Access Compliance Report

Public Rights-of-Way

(Curb Ramps)

Intersection ID: N/A	Main Street: PERIMETER_PY	Cross Street: N/A	Location: NE
ADA ID: 0923B1533832	Ramp Type: PerpDiag	Initial Pass/Fail: Fail	Overall Compliance: No
		Severity Score: 12.5

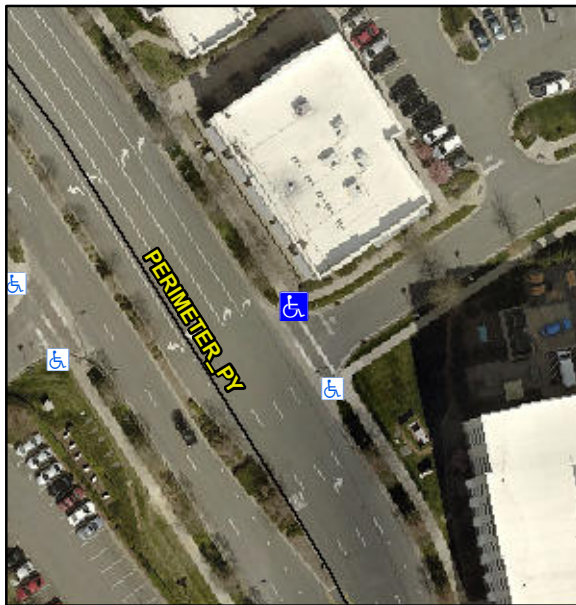
Not Found, R304.5.3

Remove & Replace Curb Ramp With Two New Directional Ramps or Equivalent.
